# M25 junction 10/A3 Wisley interchange TR010030 10.7 Transport Assessment Addendum Report

#### 10.7 Transport Assessment Addendum Report

Regulation Number	5 (2)(q)
Planning Inspectorate Scheme	TR010030
Reference	
Application Document Reference	TR010030/APP/10.7
Author:	M25 junction 10/A3 Wisley interchange project team, Highways England and Atkins

Version	Date	Status of Version
Rev 0	11 February 2020	Request for change

Figure 2-4 Amended scheme layout at Painshill junction

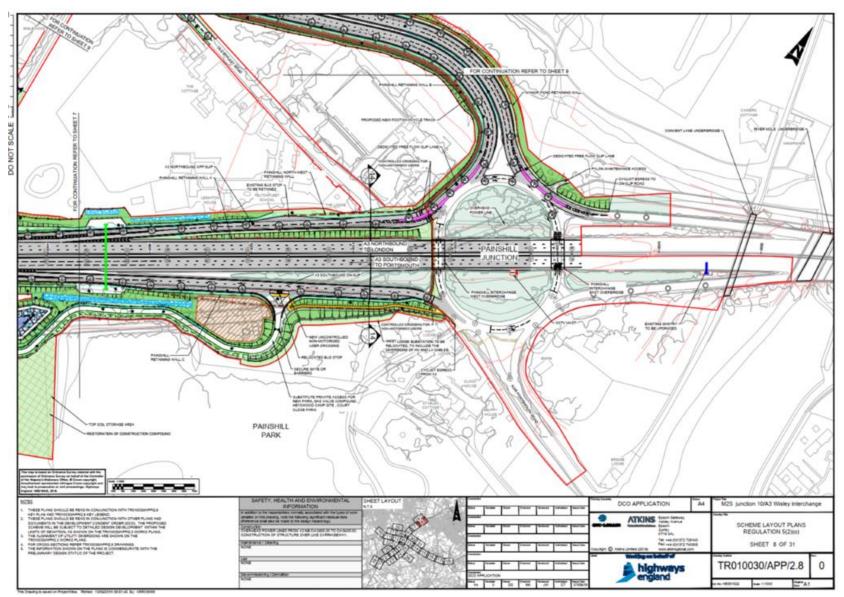
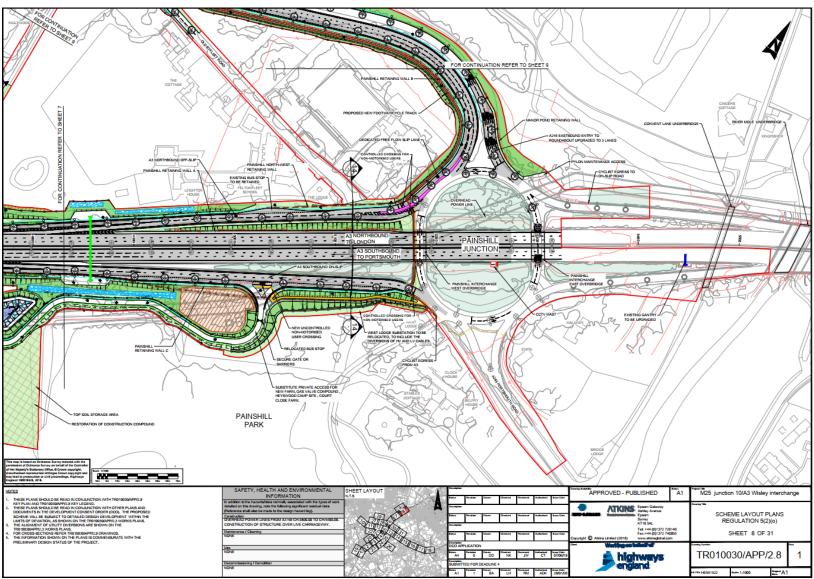
- 2.1.3 The free-flow left turn lane from the A245 eastbound to the A3 northbound at the Painshill junction has been removed from the design, with all three lanes now subject to traffic signal control.

- 2.1.4 The design allows both the left and middle lanes approaching Painshill Junction to make a left-turn, with the middle lane being a shared straight ahead and left turn lane. It is expected that most vehicles will use the left lane to complete this movement, however allowing left turning vehicles to also use the middle lane increases capacity for this movement, particularly if there is queueing in the left lane.

- 2.1.5 The scheme layout included in the dDCO submission is shown in Figure 2-1 and Figure 2-2.
- 2.1.6 The proposed changes to the scheme are shown in Figure 2-3.

Figure 2-3 Amended scheme layout at Seven Hills junction

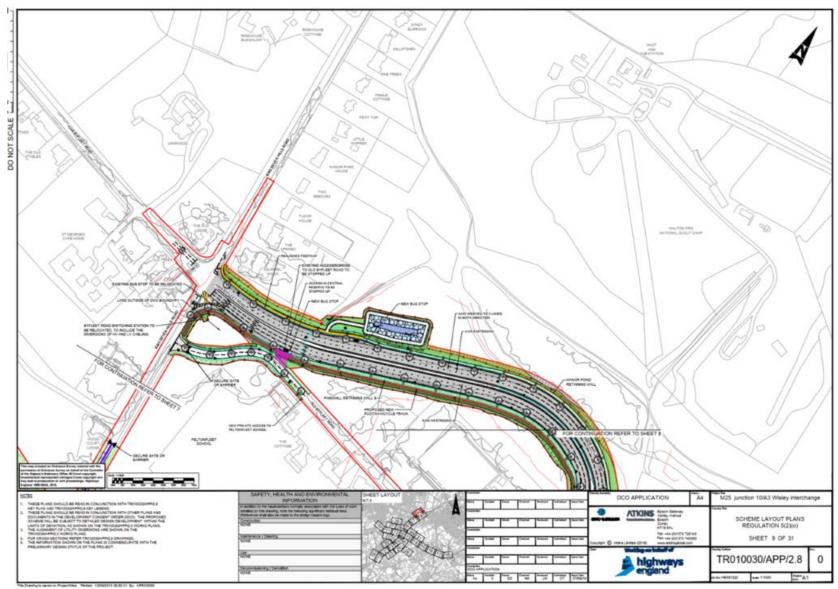
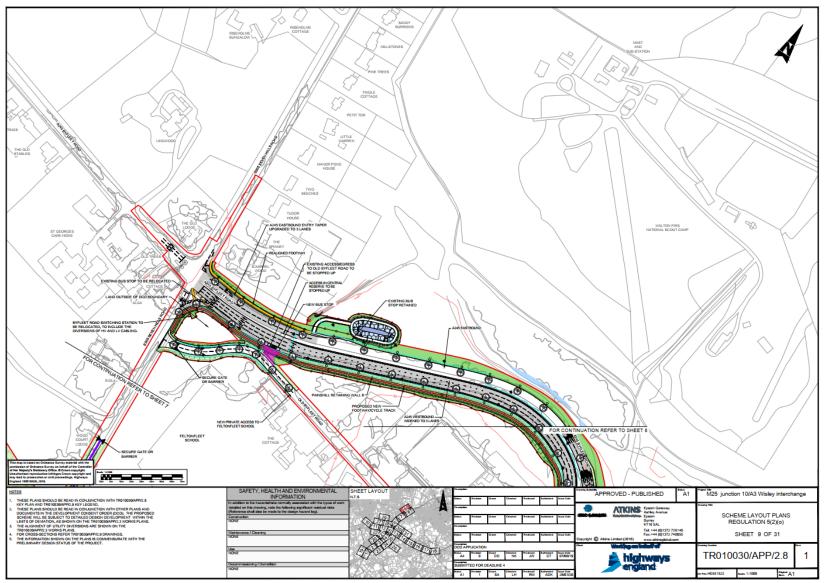
- 2.1.2 The amended design retains three lanes on the A245 eastbound through the Seven Hills junction, however this narrows down to two lanes with a merge after the exit from the Seven Hills junction. Two-lanes on the eastbound carriageway is than retained for approximately 420m before flaring to three lanes on the approach to the Painshill junction.
